# Service Bulletin

File in Section: -  
 Bulletin No.: 17-NA-265  
 Date: August, 2017

**Subject: Flutter or Boom Noise from Rear of Vehicle**

4849174

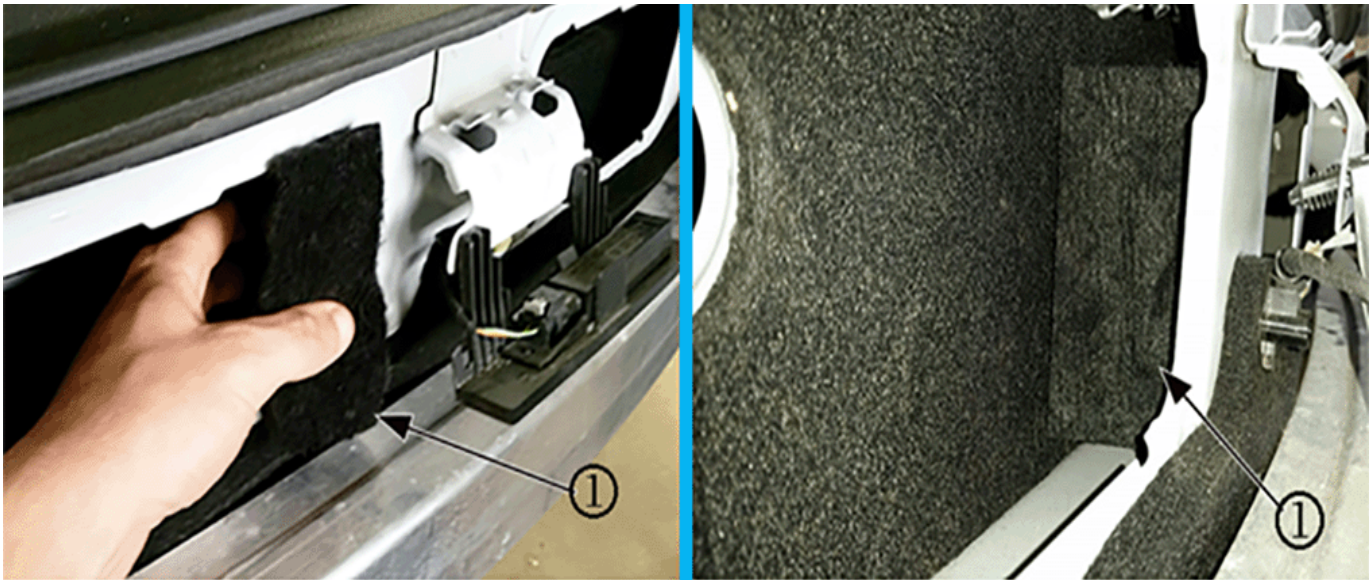
1. Remove the rear fascia and both rear pressure relief valves (PRVs). Refer to the appropriate *Body Pressure Relief Valve Replacement* procedure in SI.
2. Install the acoustic insulator panel along the backside of the chamber between the rear body panel and the inner rear panel, following these steps:

- 2.1. Slide the insulator panel (1) into one of the PRV openings.

- Important:** Ensure that the insulator panel is centered and DOES NOT BLOCK any of the holes in the body.
- 2.2. Center the insulator along the back side of the chamber.
  - 2.3. Tuck the outside edges of the panel into the corners.

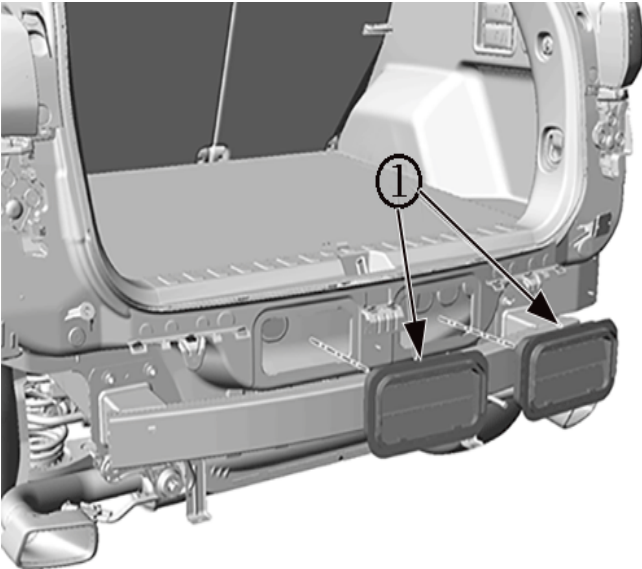
3. Install the acoustic insulator block (1) in the middle of the chamber, between both PRVs.
